SUMMER WOODS SUBDIVISION, PHASE THREE

APPLICATION NUMBER 14 DATE February 19, 2009

DETAIL SITE PLAN

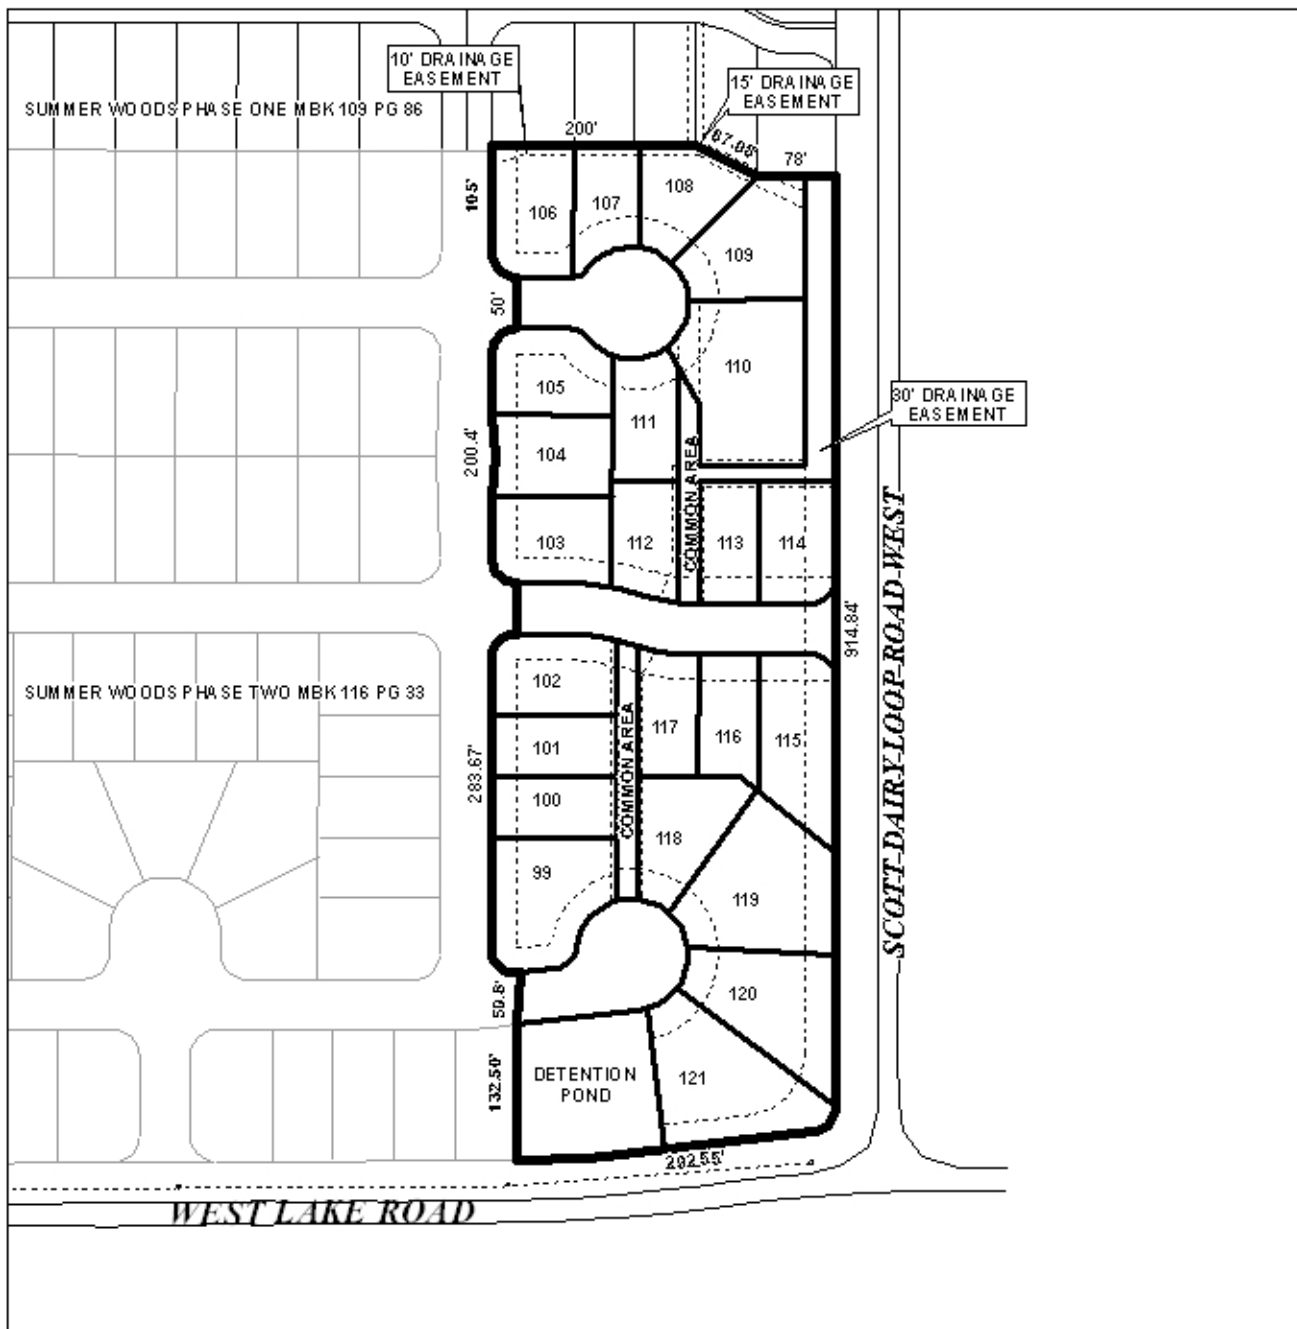
The plat indicates a varying building setback line of 25' to 30' along all interior street frontages and this should also be indicated on the final plat. A varying 25' to 30' drainage easement is proposed along West Lake Road and Scott Dairy Loop Road West which would negate the necessity of a minimum building setback line along those street frontages. These should also be illustrated on the final plat.

Lot sizes are not indicated on the plat; therefore the plat should be revised to label each lot with its size in square feet, or a table should be furnished on the plat providing the same information.

A review of the original Summer Woods Subdivision plat indicates the presence of a small wetlands area where proposed Lots 109 and 110 are indicated, and meandering along the area of the proposed central drainage easement to the detention pond in the Southwest corner of the subdivision. Because of the wetlands presence, a note should be placed on the final plat stating that approval of all applicable Federal, state and local agencies is required for endangered, threatened or otherwise protected species, if any, prior to the issuance of any permits or land disturbance activities. Since easements are to be provided, a note should be placed on the final plat stating that no construction is allowed within any easement. As on the preliminary plat, a note should be placed on the final plat stating that the maintenance of all common areas is the responsibility of the property owners and not Mobile County.

- 4) revision of the plat to indicate a 120' right-of-way diameter for all cul-de-sacs as per the 2003 IFC standard;
- 5) illustration of the minimum building setback line along all interior street frontages and the drainage easement along West Lake Road and Scott Dairy Loop Road West;

- 6) revision of the plat to label each lot with its size in square feet, or the furnishing of a table on the plat providing the same information;
